SUBJECT: Application for amends to Licenses NPF-41 & NPF-51, revising  
 Tech Spec 3.7.1.3 to change required storage tank level from  
 existing 23 ft to indicated level of 25 ft. Fee paid.

Subject: Palo Verde Nuclear Generating Station (PVNGS)  
Units 1 and 2  
Docket Nos. STN 50-528 (License No. NPF-41)  
STN 50-529 (License No. NPF-51)  
Proposed Technical Specification Change - Condensate Storage Tank Level  
File: 87-E-056-026; 87-F-056-026; 87-F-005-419.05

This proposed Technical Specification change revises Limiting Condition for Operation (LCO) 3.7.1.3 to change the required minimum level in the Condensate Storage Tank (CST) from 23 feet to an indicated level of 25 feet.

# FIGURE 1: CONDENSATE STORAGE TANK LEVELS

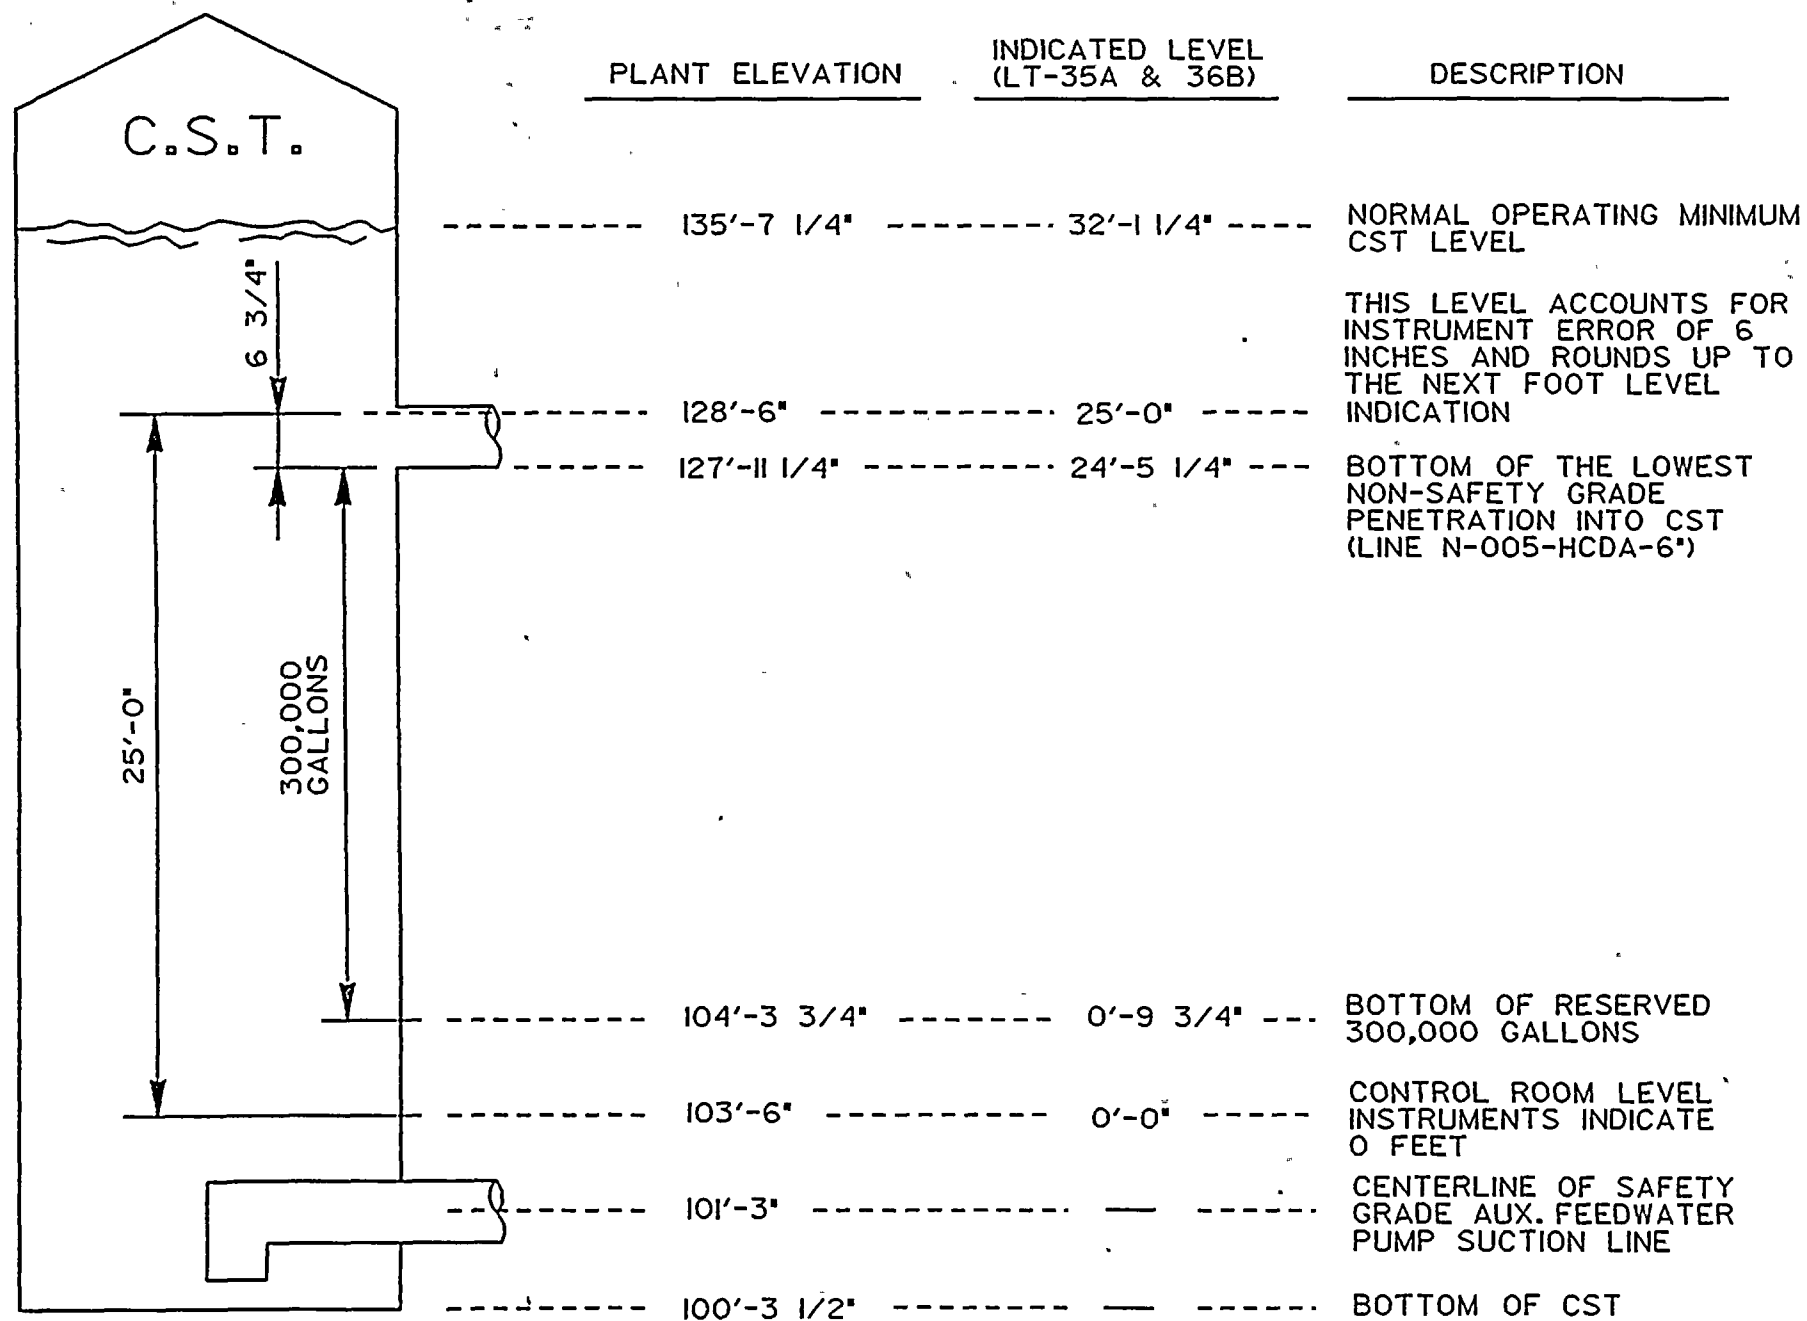
Figure 1 shows the relevant elevations of the condensate storage tank to explain this proposed Technical Specification change. As shown in Figure 1, the reserved 300,000 gallons is measured from plant elevation 104' - 3 3/4" to the bottom of the lowest non-safety grade penetration into the CST at plant

elevation 127' - 11 1/4". These plant elevations correspond to control room indicated levels of 9 3/4" and 24' - 5 1/4", respectively. When instrument error is accounted for, the required indicated level is 25 feet. It should be noted that the instrument error is applied in the conservative direction (i.e., requires a higher CST level) such that the required 300,000 gallon volume is assured as long as the indicated CST level is 25 feet.
